Re: Petition No. Petition 1346 - Manchester 3A Substation

Response to CSC-01 Interrogatories dated 06/22/2018
CSC-001, 002, 003, 004, 005, 006, 007, 008, 009, 010, 011, 012, 013

**CL&P dba Eversource Energy
Petition No. Petition 1346**

**Data Request CSC-01
Dated: 06/22/2018
Q-CSC-001
Page 1 of 1**

A-1

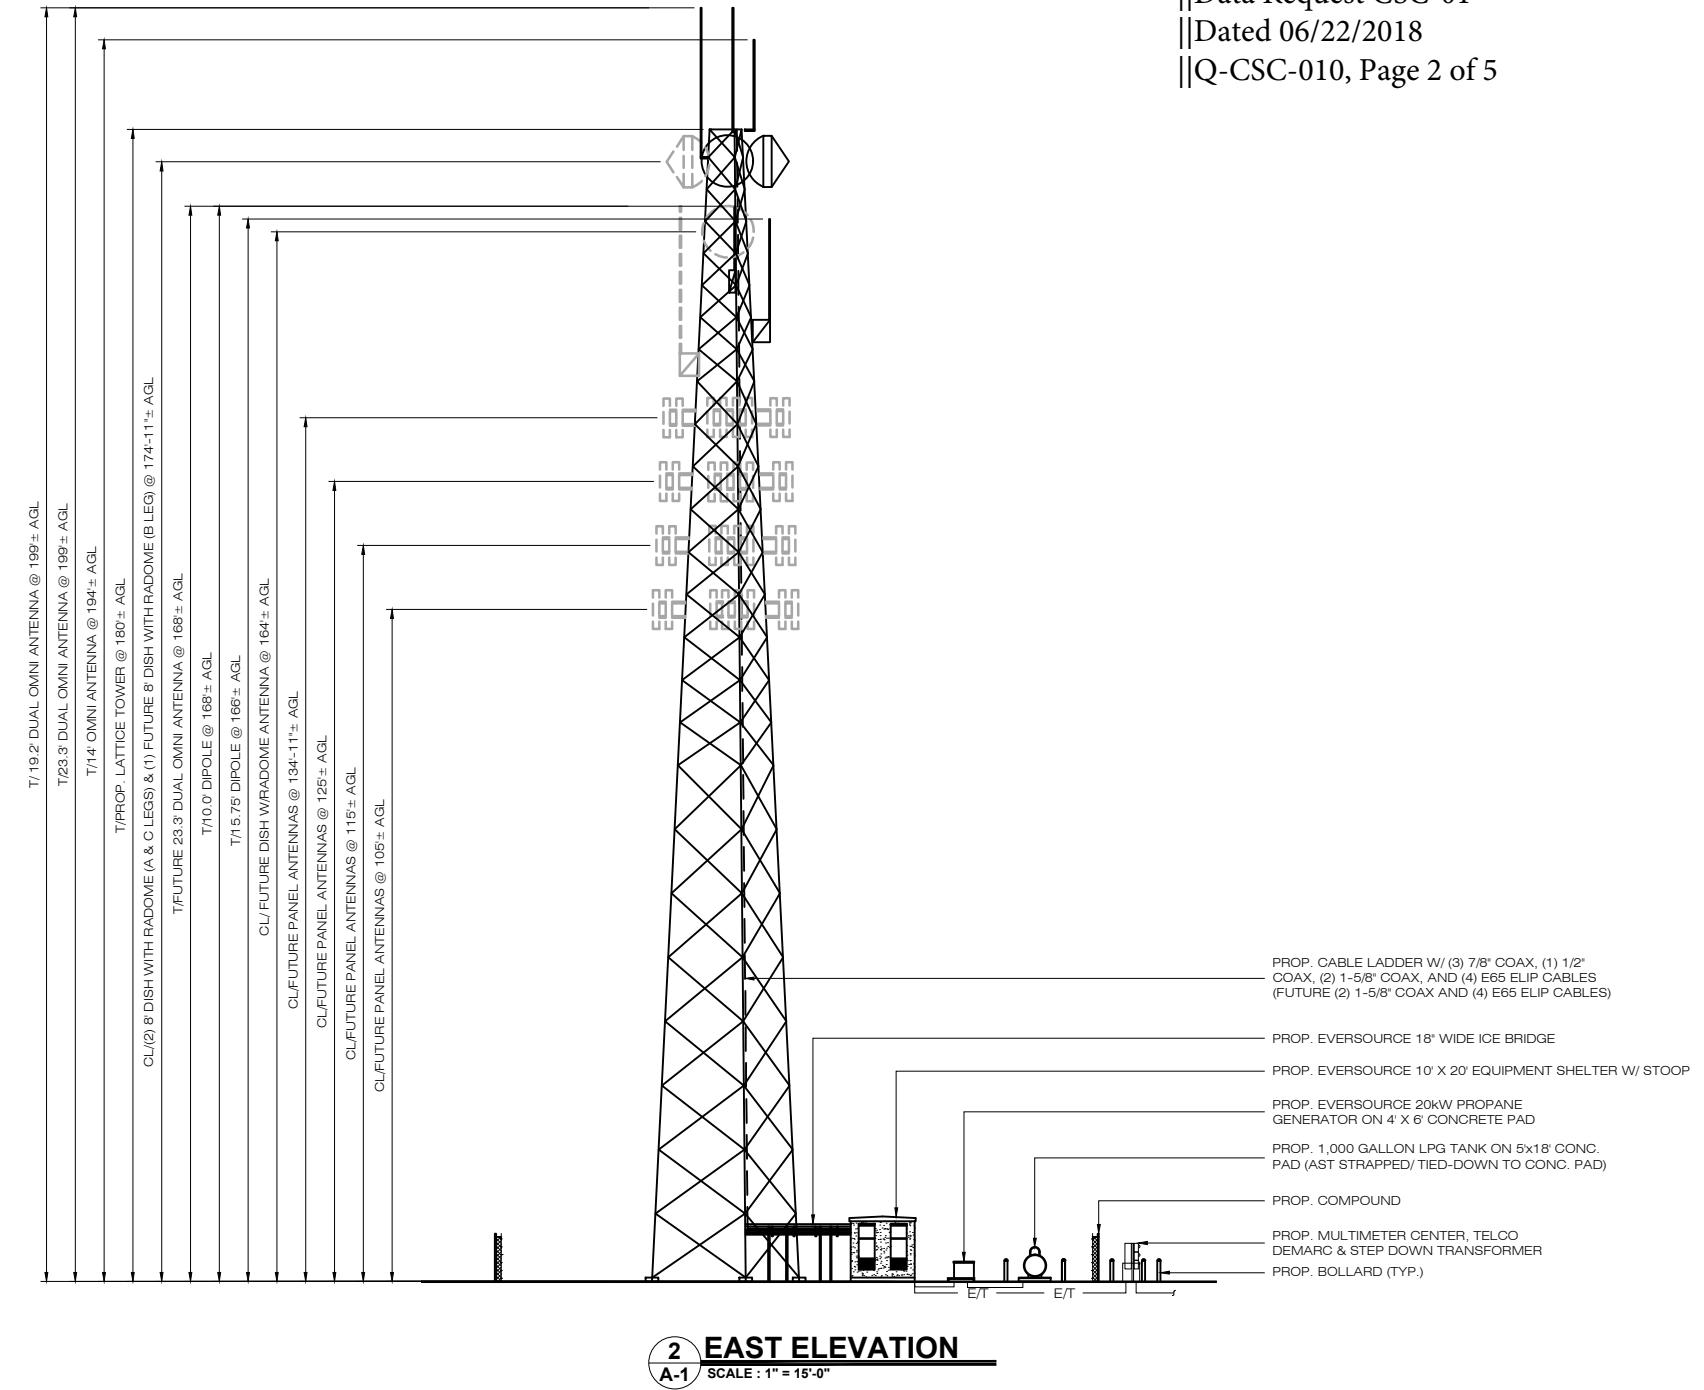
- a) Sheet A-1 shows a "T/20.0' Dual Omni Antenna" and a "T/21.0' Dual Omni Antenna." Table 1 shows a "19-ft Dual Omni" antenna and a "23-foot Dual Omni" antenna. Please reconcile drawing A-1 with the inventory on Table 1.
- b) Should the "19-ft Dual Omni" antenna on Table 1 be approximately 21 feet long per its specifications sheet?
- c) Sheet A-1 shows a "T/20.0' Dipole" antenna and a "T/10.0' Dipole" antenna. Table 1 shows a "10-foot Dipole" antenna and a "15-foot Dipole" antenna. Please reconcile drawing A-1 with Table 1.
- d) Please correct Sheet A-1 and Table 1 if necessary.

- a) The information contained in Table 1 for the "19.2-ft Dual Omni" antenna and the "23.3-ft Dual Omni" antenna has been modified to be more exact. Attached is SHEET A-1, REV. 2: 07/02/18, which includes the revision to the correct antenna information.
- b) Attached is a revised specification sheet for the dbSpectra "19.2-ft Dual Omni" antenna.
- c) The correct antennas are a "T/10.0 Dipole" and a "T/15.75 Dipole". Both Sheet A-1 and Table 1 have been revised accordingly and the revised versions are attached.
- d) The revised versions of Sheet A-1 and Table 1 with the above-referenced corrections are attached.

Attachment 3: Antenna Specifications (Revised Specification - dbSpectra Antenna)

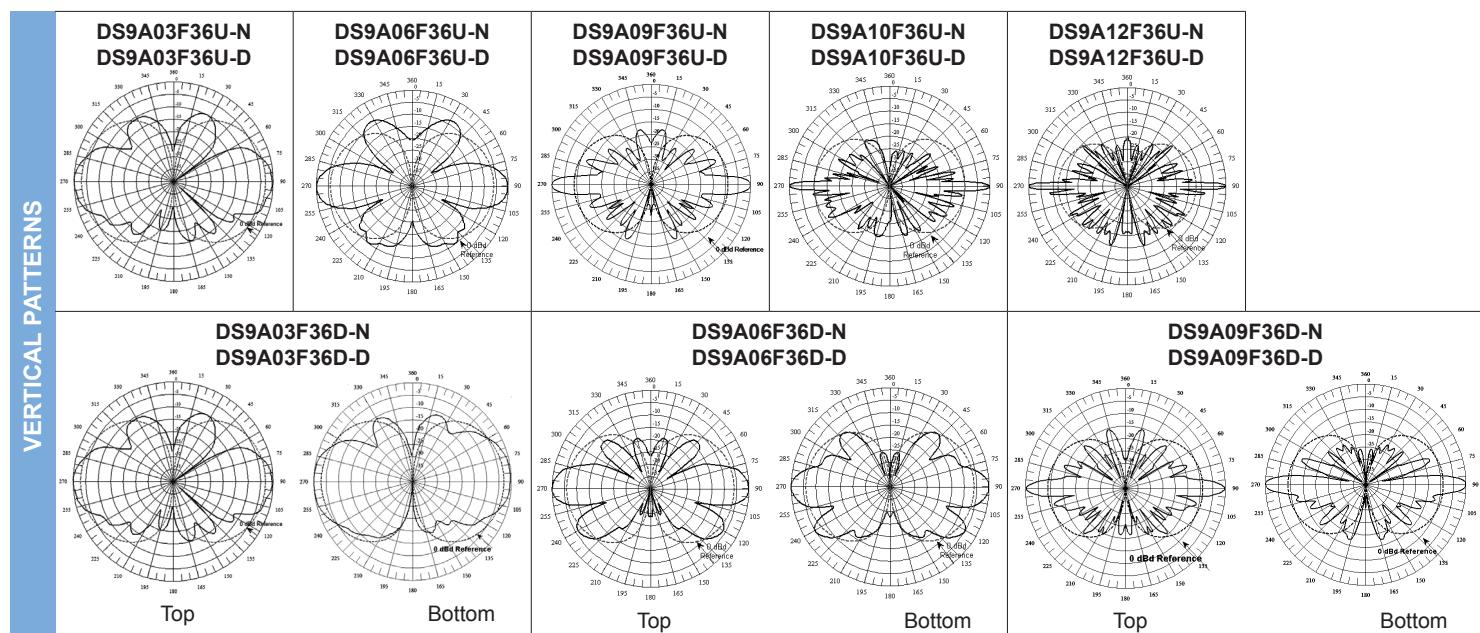
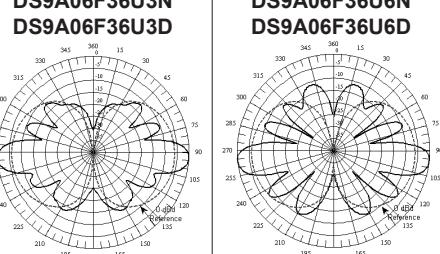
- a) Sheet A-1 shows a "T/20.0' Dual Omni Antenna" and a "T/21.0' Dual Omni Antenna." Table 1 shows a "19-ft Dual Omni" antenna and a "23-foot Dual Omni" antenna. Please reconcile drawing A-1 with the inventory on Table 1.
- b) Should the "19-ft Dual Omni" antenna on Table 1 be approximately 21 feet long per its specifications sheet?
- c) Sheet A-1 shows a "T/20.0' Dipole" antenna and a "T/10.0' Dipole" antenna. Table 1 shows a "10-foot Dipole" antenna and a "15-foot Dipole" antenna. Please reconcile drawing A-1 with Table 1.
- d) Please correct Sheet A-1 and Table 1 if necessary.

- a) The information contained in Table 1 for the "19.2-ft Dual Omni" antenna and the "23.3-ft Dual Omni" antenna has been modified to be more exact. Attached is SHEET A-1, REV. 2: 07/02/18, which includes the revision to the correct antenna information.
- b) Attached is a revised specification sheet for the dbSpectra "19.2-ft Dual Omni" antenna.
- c) The correct antennas are a "T/10.0 Dipole" and a "T/15.75 Dipole". Both Sheet A-1 and Table 1 have been revised accordingly and the revised versions are attached.
- d) The revised versions of Sheet A-1 and Table 1 with the above-referenced corrections are attached.
